## CITY OF ALBUQUERQUE

RE: Lot 16 Block 1 Unit 18 S.A.D. 227 6809 Rimrock NW Grading and Drainage Plan Engineers Stamp Date 12/16/18 (E10D014)

#### DRAINAGE AND TRANSPORTATION INFORMATION SHEET (REV 6/2018)

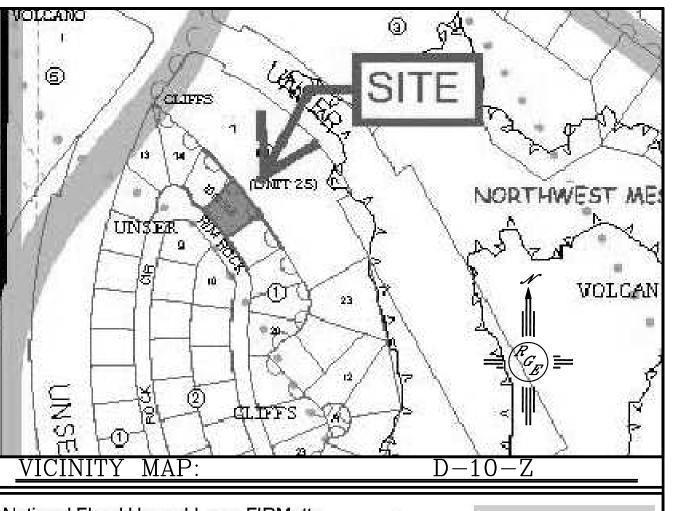
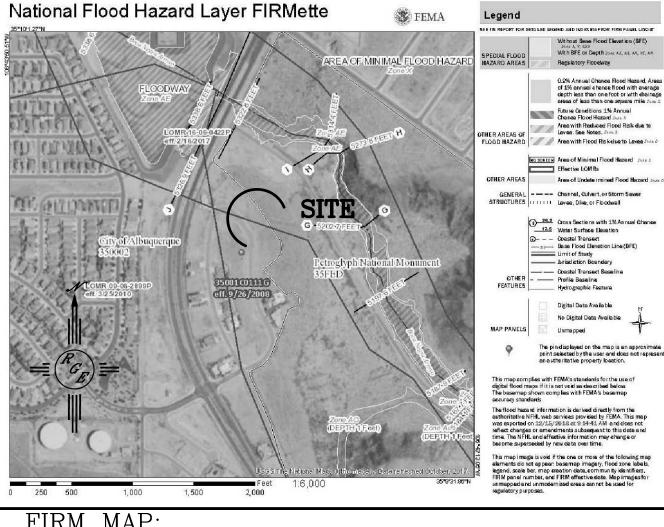
Based upon the information provided in your submittal received 12/17/18, this plan is approved for Grading Permit. Please inform the builder/owner to attach a copy of this approved plan and letter into the construction sets in the permitting process prior to sign-off by Hydrology.

Reiterate to the Owner/Contractor that a separate permit for any garden/retaining wall must be obtained, with the approved G&D plan.

Prior to Building Permit approval, a Pad Certification will be required.

Prior to **Certificate of Occupancy release**, Engineer Certification per the DPM checklist of this plan will be required.
